LAA/AWA/20/13
30th May 2020

Dynon Technical Service Bulletin Kavlico Fluid Pressure Sensors

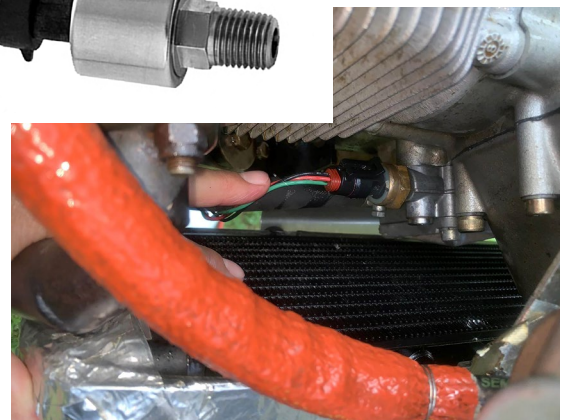
Even though the oil pressure sensor requires only a minuscule amount of pressurised oil to do its job, if the sensor springs a leak, oil can be lost from the engine really quickly. The above picture shows the result after a Kavlico pressure sensor, required in this case, to feed information to the Dynon EFIS, failed in service.

Regular and detailed of all the various components inside the engine compartment must be inspected regularly. This picture shows the Kavlico sensor whose failure led to the catastrophic oil loss shown above. The inset picture shows an up-rated sensor which are now available from Dynon.

Should a leak be discovered in a Kavlico fluid pressure sensor, even a small one, the sensor should be replaced with an up-rated part before further flight.
